CITY OF ALBUQUERQUE

**Re: Signal Pointe Subdivision
Signal/Ventura
Grading and Drainage
Engineers Stamp Date 8/20/2015 (C20D070)**

Based upon the information provided in your submittal received 8/21/2015, the above referenced Grading and Drainage Plan is approved based on the following conditions:

GRADING & DRAINAGE PLAN

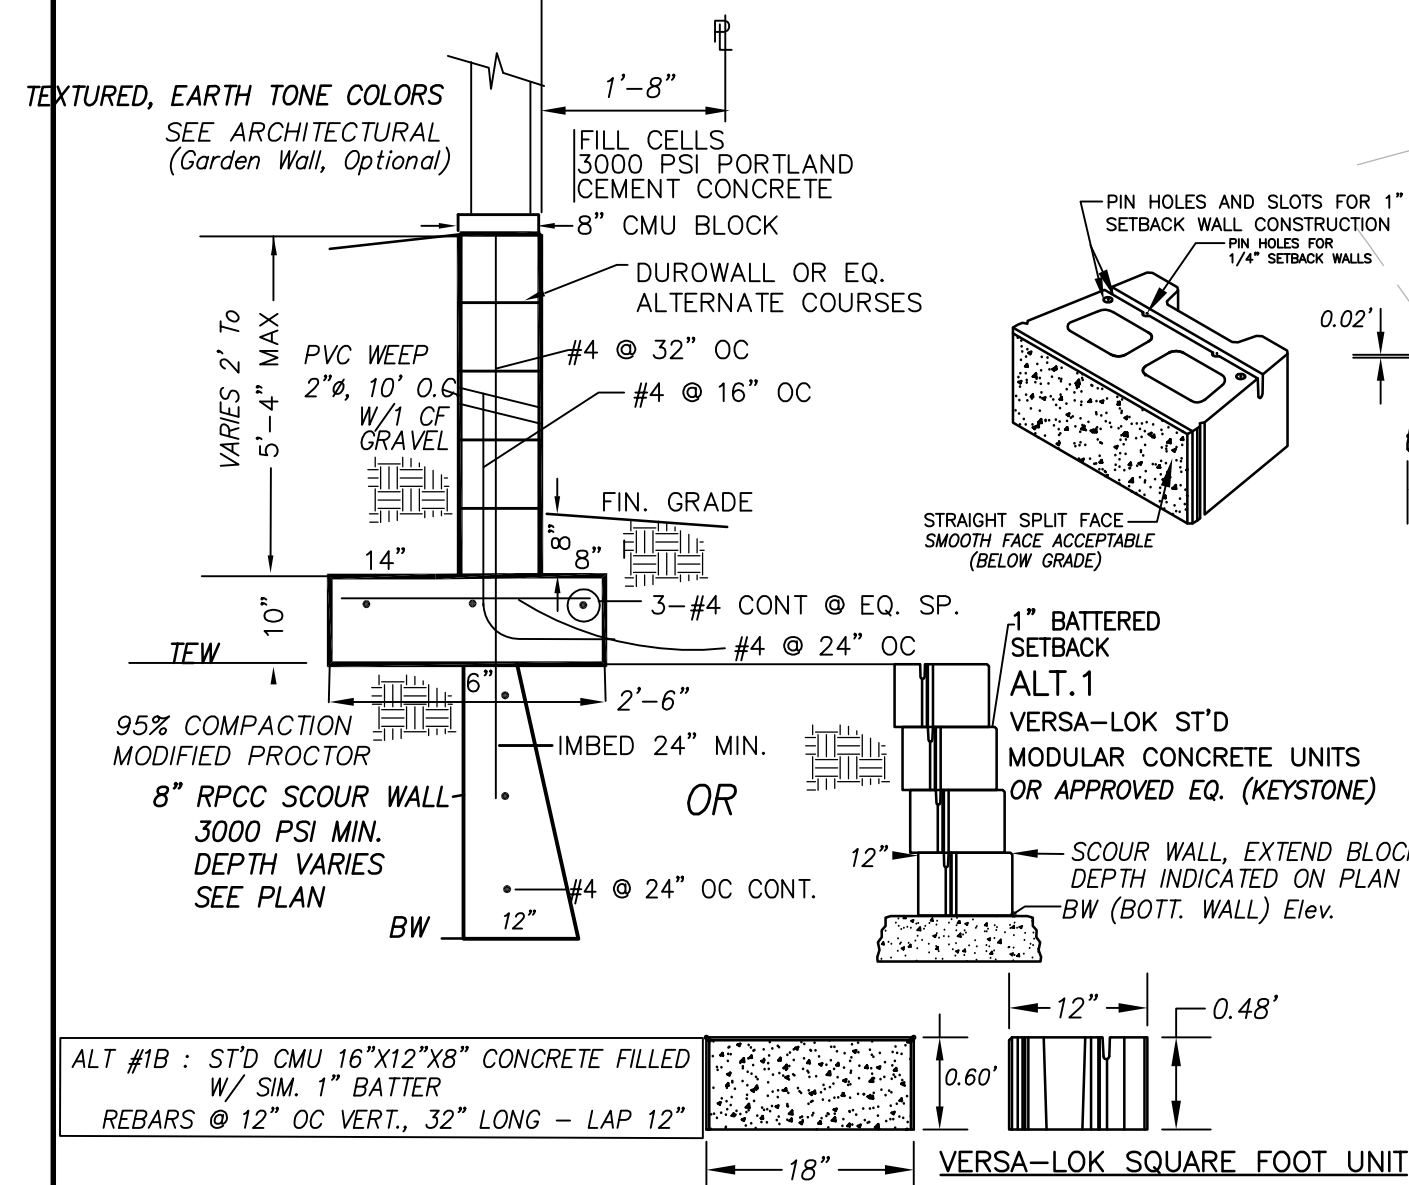
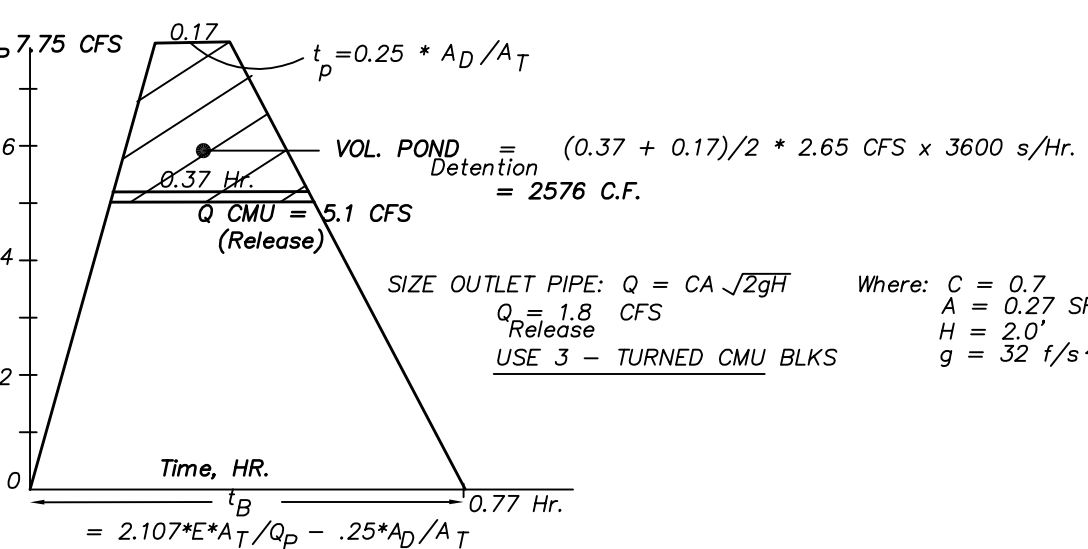
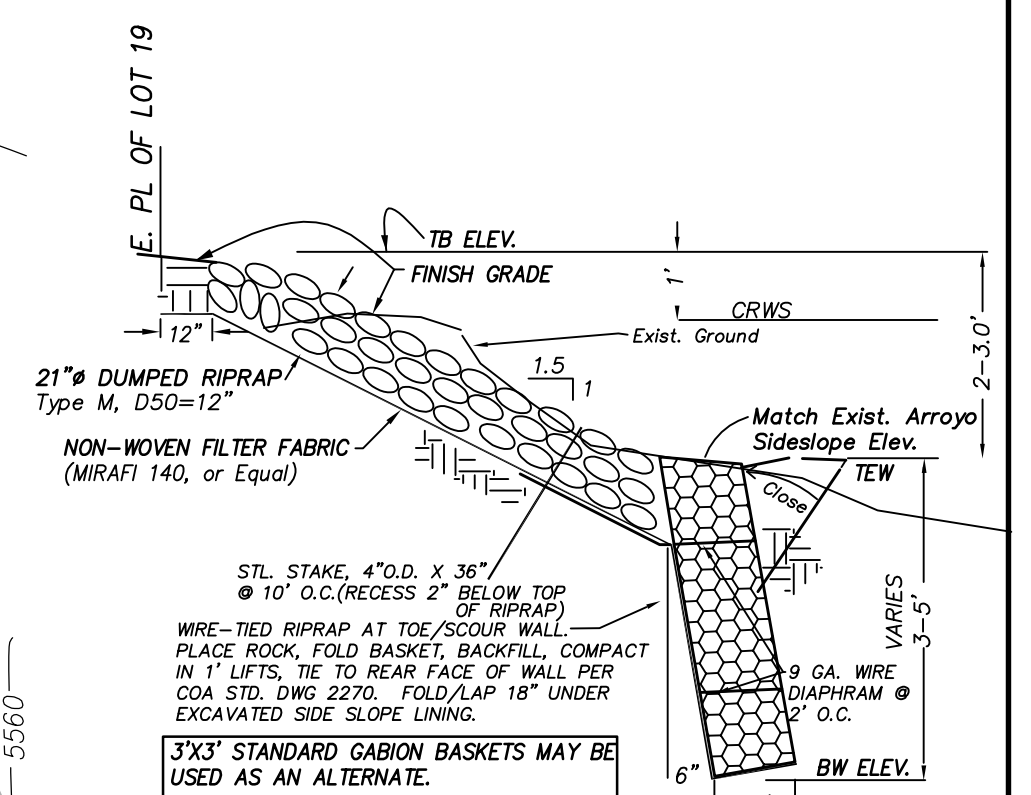
- The wall should remain in place once the erosion occurs. Please design the flood control structures accordingly. The wall detail/calculations/specifications must be clearly shown on the DRC plans.
- Provide plan and profile sheets for the flood control structure including the top and bottom elevations.
- Clearly show the limits (including stations) of Riprap Erosion Control Lining shown on Section A and the proposed floodwall on the DRC plan.
- Grading Certification will be required prior to release of Financial Guarantee, Workorder and building permits.
